Crystal River Nuclear Plant
Docket No. 50-302
Operating License No. DPR-72

August 21, 2012
3F0812-02

Subject: Crystal River Unit 3 – Response to Second Request for Additional Information to Support NRC Electrical Engineering Branch (EEEB) Technical Review of the CR-3 Extended Power Uprate LAR (TAC No. ME6527)

**RESPONSE TO SECOND REQUEST FOR ADDITIONAL
INFORMATION – ELECTRICAL ENGINEERING BRANCH
TECHNICAL REVIEW OF THE CR-3 EPU LAR**

Figure 1
Markup of FSAR Figure 8-2 – Electrical One Line Diagram Composite

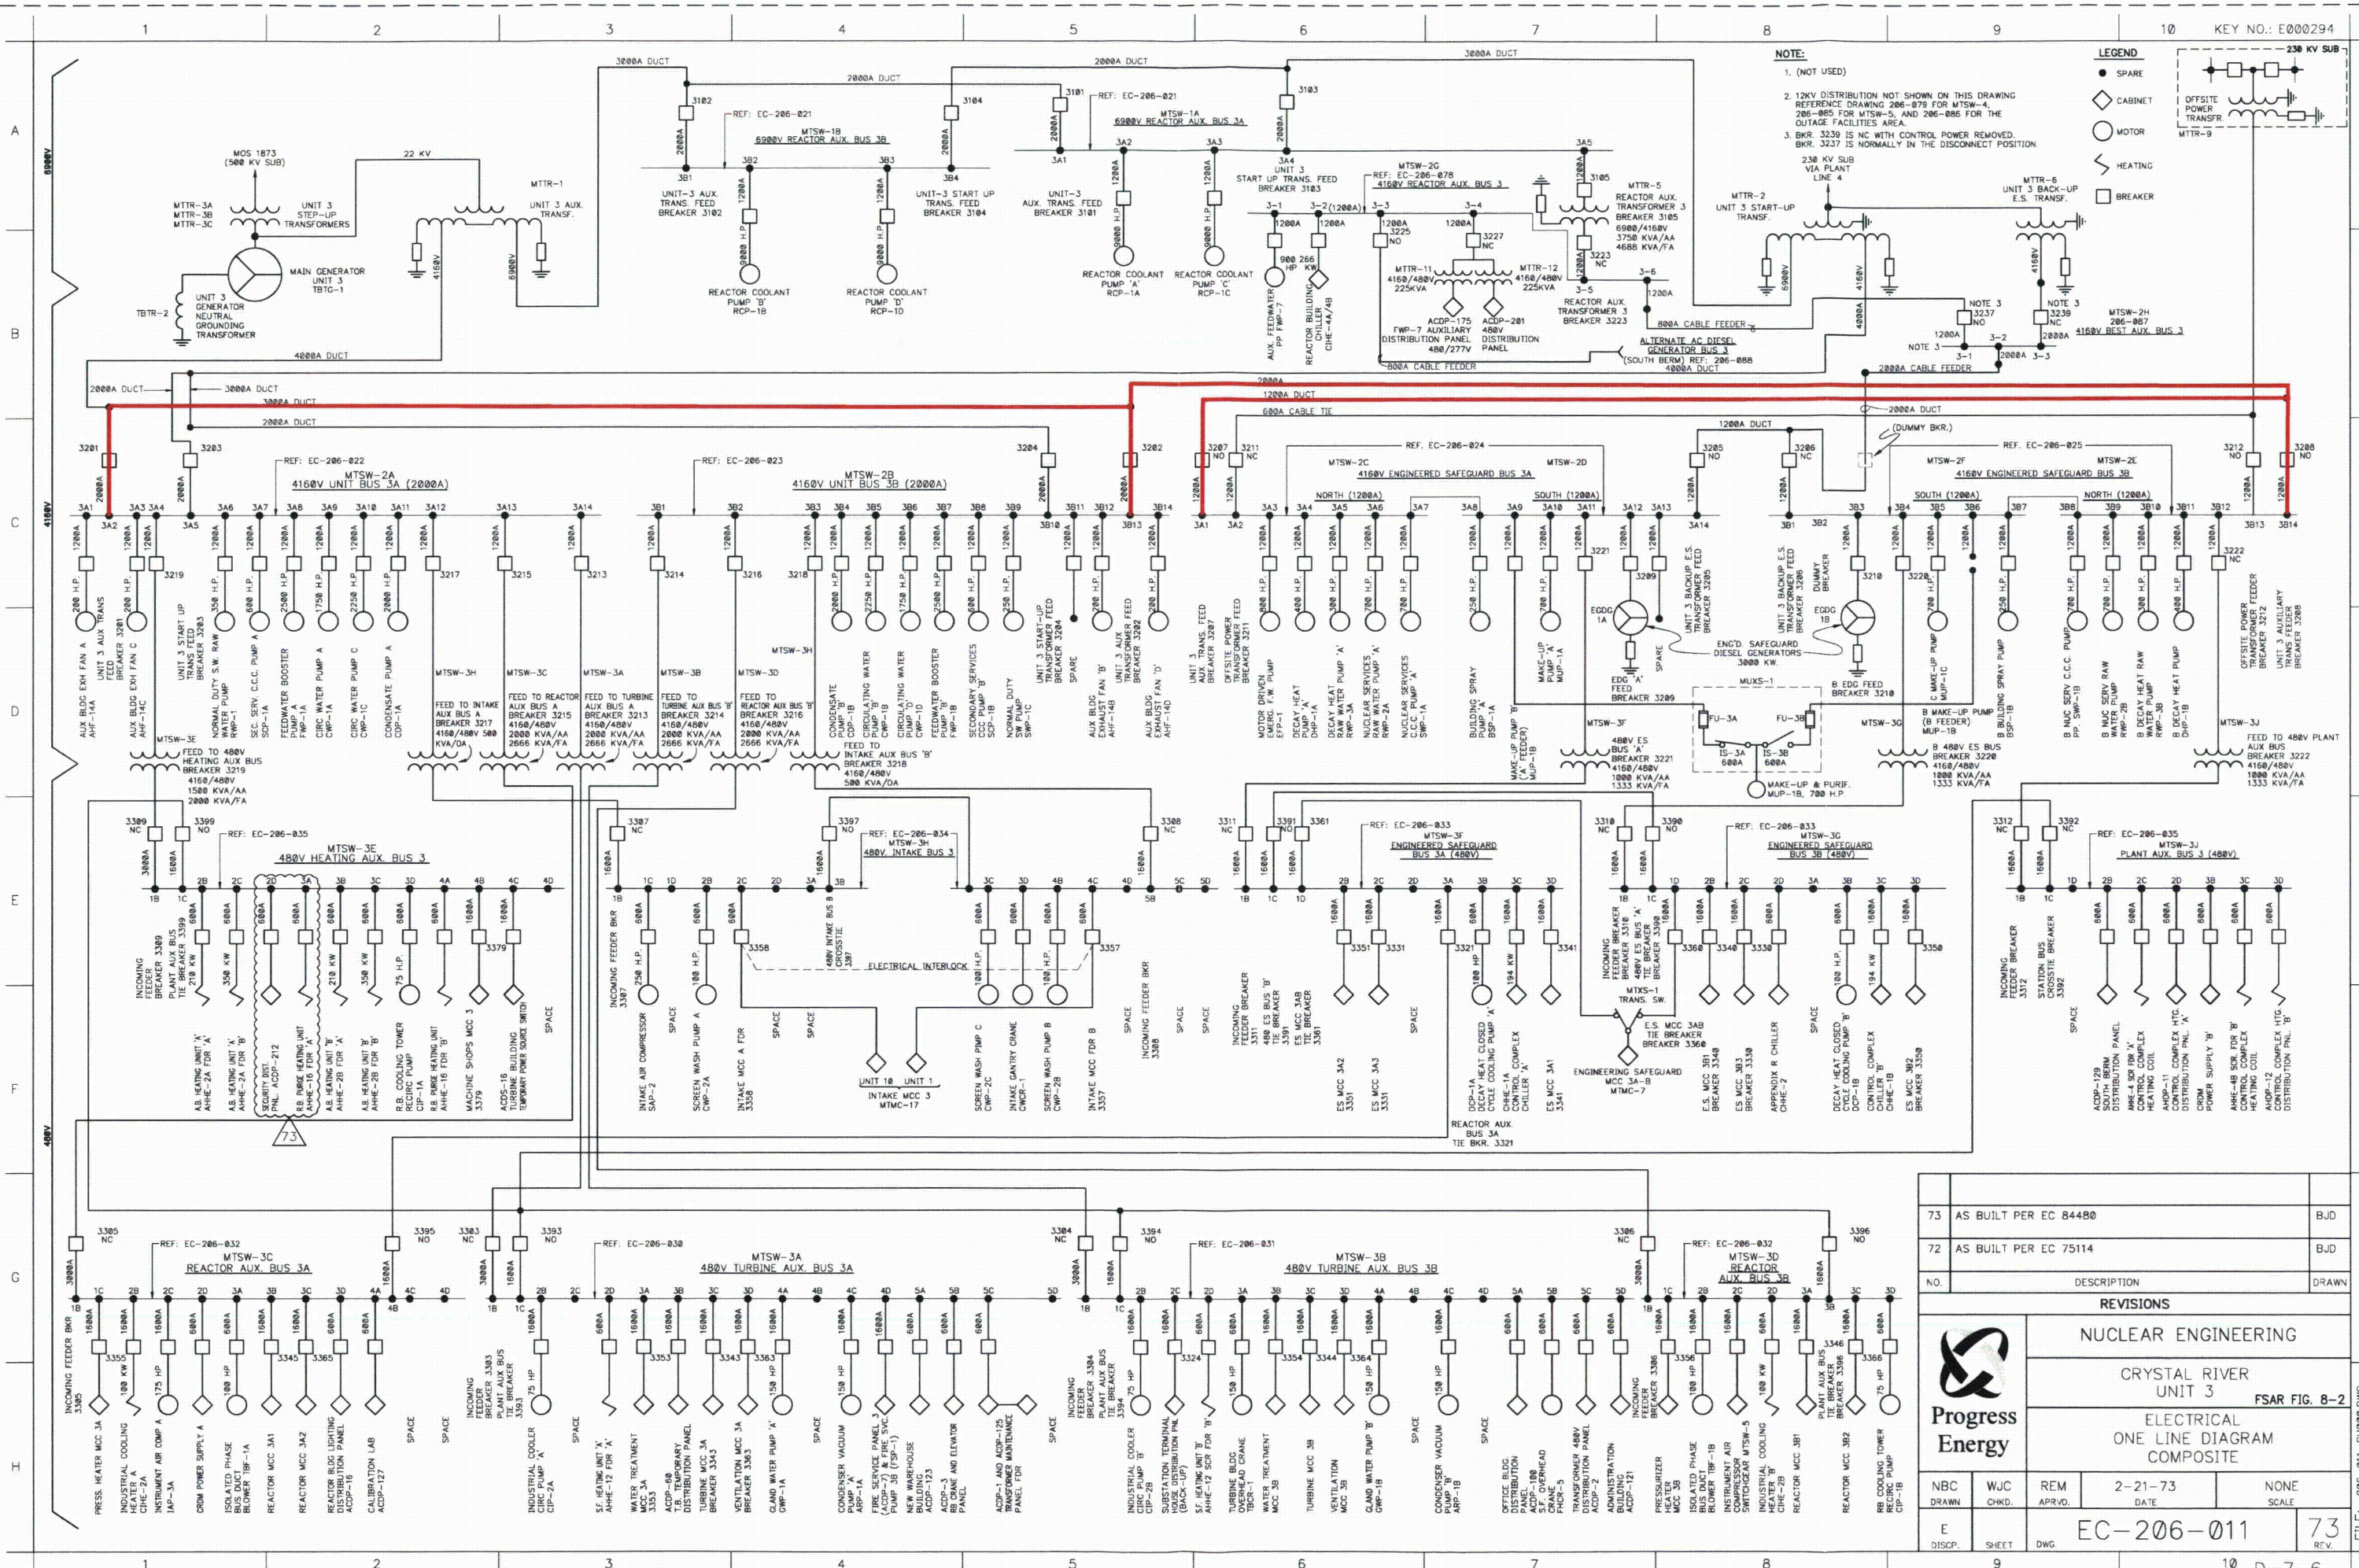
In response to EEEB 1-11 dated April 16, 2012, the licensee stated that subsequent to the submittal of the CR-3 EPU LAR, the licensee discovered an incorrect design input in the nonsafety related electrical transient analyzer program analysis. This condition was evaluated in the corrective action program and the short-circuit analysis has been re-done. The analysis indicates that the short-circuit ratings are exceeded at EPU conditions on several nonsegregated bus ducts that require modification for higher short-circuit rating. As a result, the licensee stated that the five 4160 volt nonsegregated bus duct sections will be replaced prior to EPU operation.

Identify the five 4160 volt nonsegregated bus duct sections discussed above and provide the continuous and short-circuit current ratings at EPU operation. Clarify if this modification is a part of the Regulatory Commitment in Attachment 10 of the LAR, where it is stated that “CR-3 will implement all EPU modifications.”

The sections of the 4160 V non-segregated bus duct that are identified for replacement to support CR-3 operation are indicated in Figure 1, “Markup of FSAR Figure 8-2 – Electrical One Line Diagram Composite,” and Figure 2, “Isometric of 4160 V Non Segregated Bus Replacement Project,” of Enclosure 3, “CR-3 Electrical Figures,” to this attachment and include the bus duct sections between 4160 V engineered safeguard (ES) buses 3A and 3B, and, the 4160 V unit buses 3A and 3B. Table 2, “Replacement Bus Duct – EPU Continuous and Short-Circuit Ratings and Duty,” provides a list of the continuous and short-circuit ratings of each of the modified sections of non-segregated bus duct and the continuous and short-circuit duty of the bus sections in operation at EPU conditions.

As shown in Table 2, the continuous duty of the 4160 V nonsegregated bus duct sections remain within the associated continuous ratings. However, replacement of these nonsegregated bus duct sections is required to ensure the short-circuit fault current is within the momentary short-circuit rating of the nonsegregated bus duct at EPU conditions. Therefore, this modification is a required modification for implementing EPU at CR-3 and is included in the scope of modifications identified in the second regulatory commitment in Attachment 10 of the EPU LAR (Reference 1).

Figure 3
CR 3 FSAR Figure 8-8A – Electrical One Line Diagram 250/125V DC System

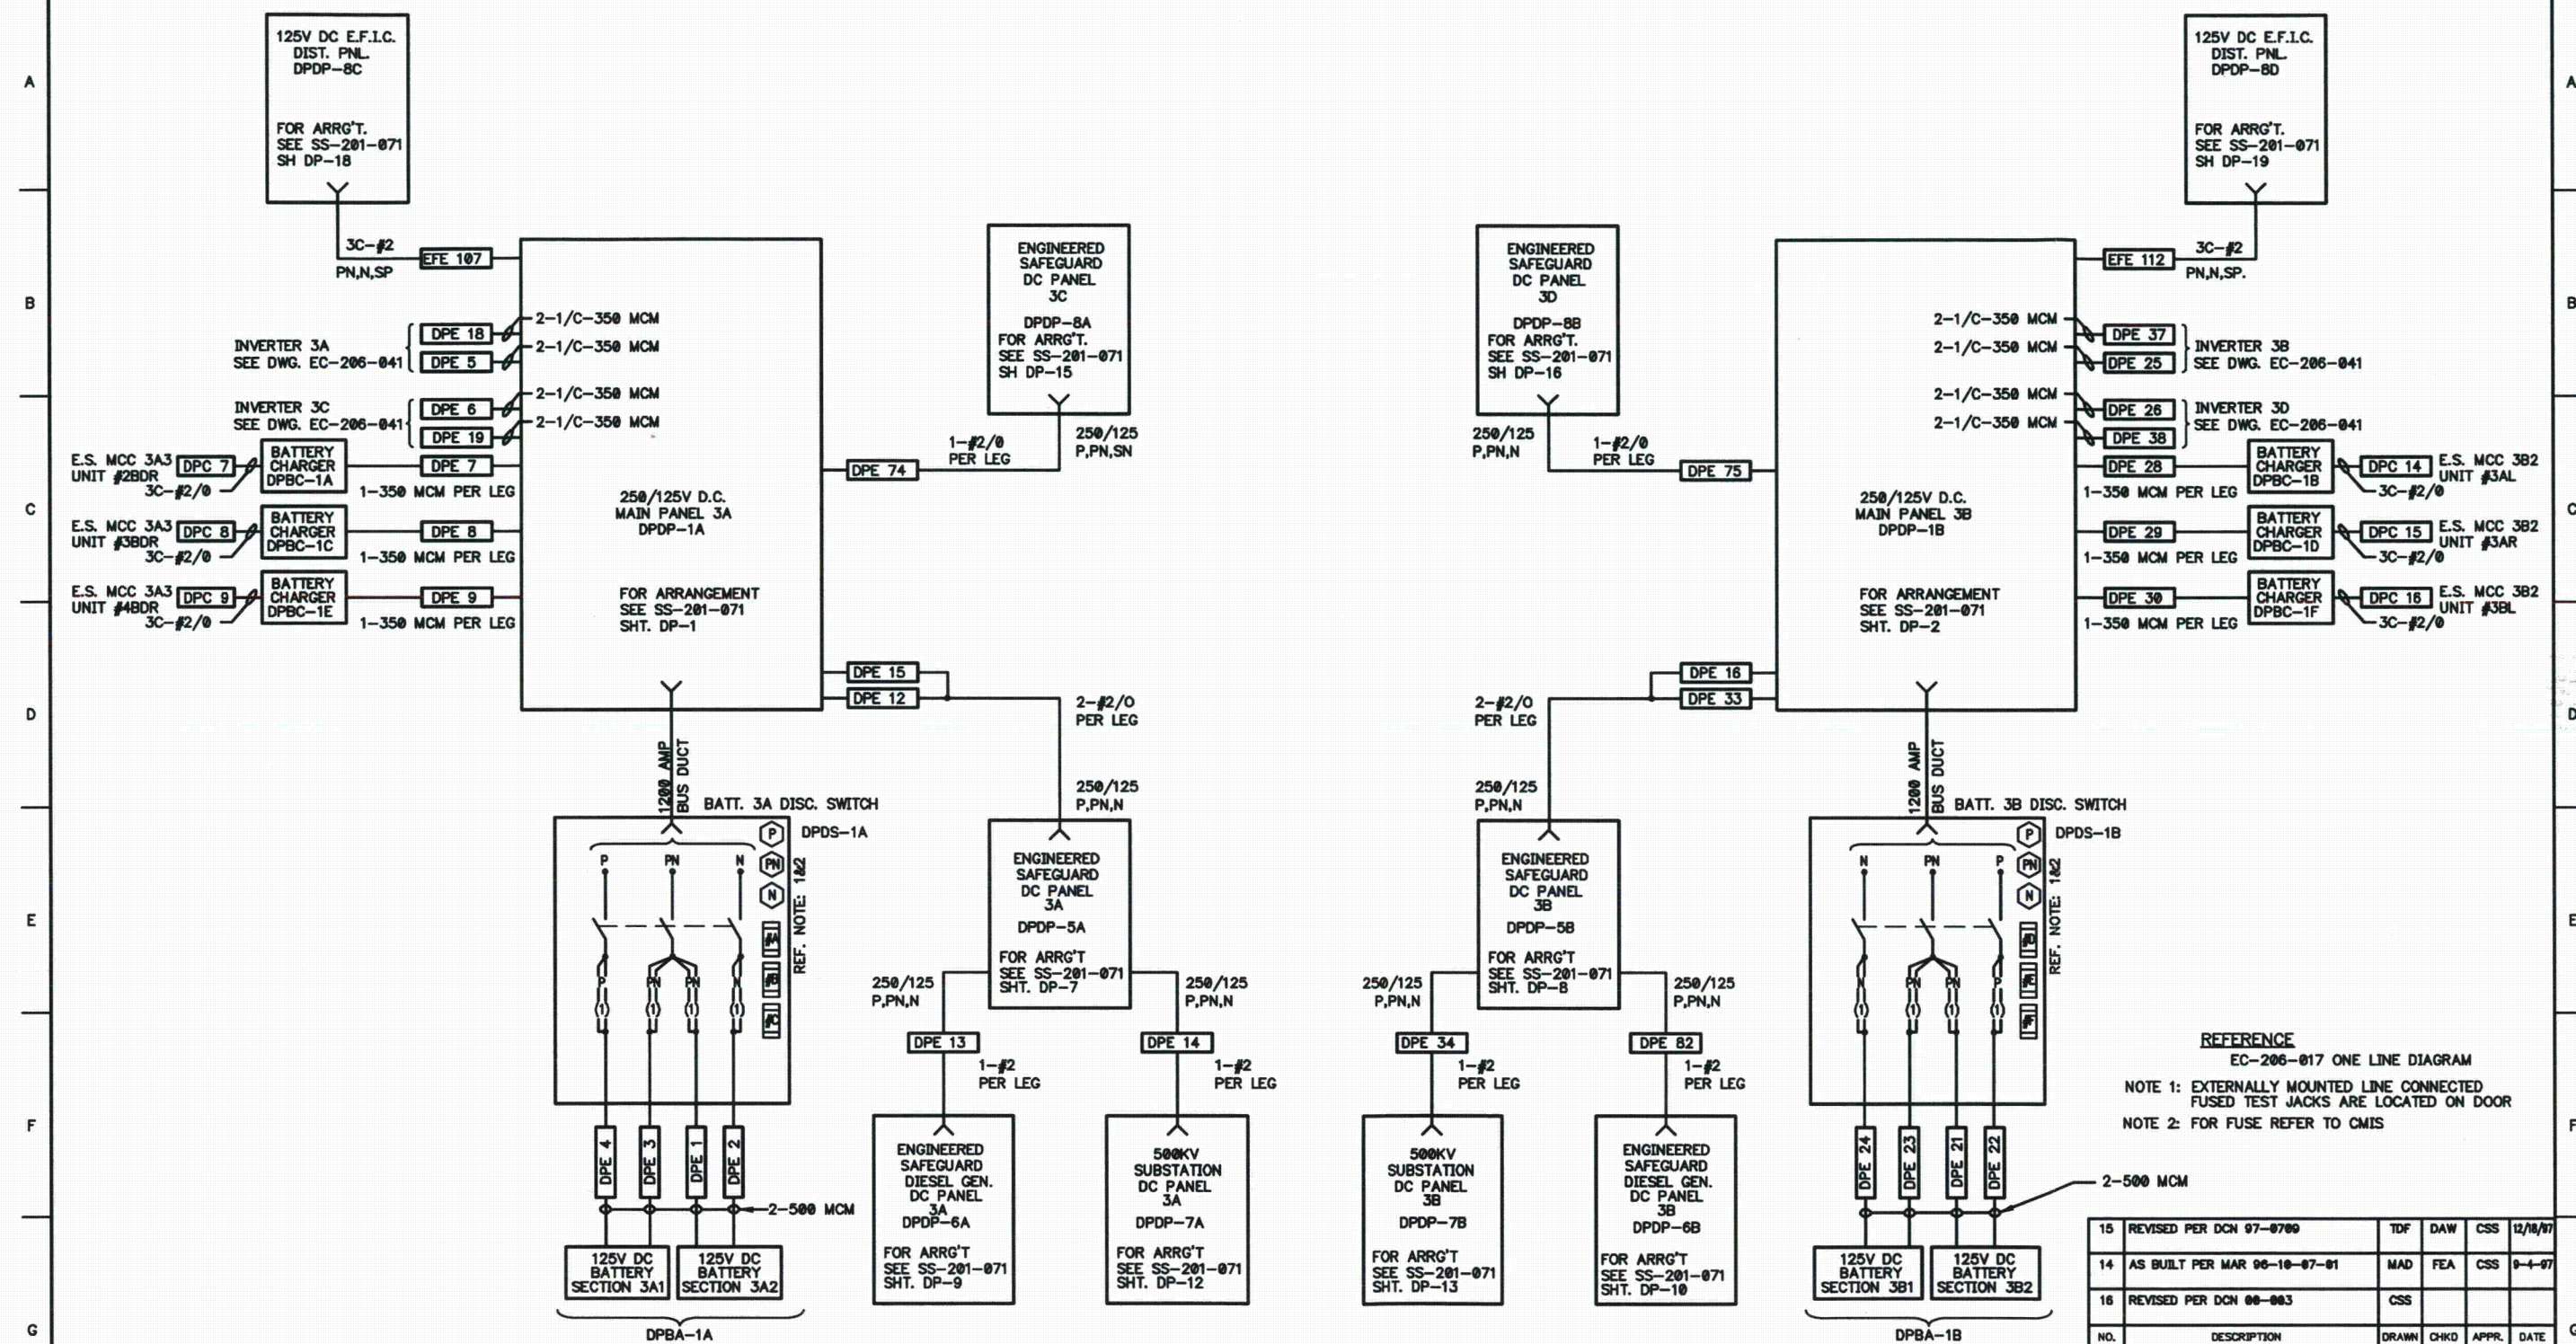
- a) Provide the latest direct current (DC) one line diagram of the Class 1E battery and the EFP-3 battery systems. Provide a discussion on the configuration of the B-positive and B-negative Class 1E station batteries.

Figure 3, "CR-3 FSAR Figure 8-8A – Electrical One Line Diagram 250/125V DC System," and Figure 4, "Simplified 125/250 VDC Electrical Power System Train One Line Diagram,"

are provided in Enclosure 3 to this attachment. Figure 3 is a block diagram showing the Class 1E batteries, chargers, and DC electrical distribution panels. Figure 4 is a simplified electrical schematic of one train of the Class 1E batteries and associated chargers.
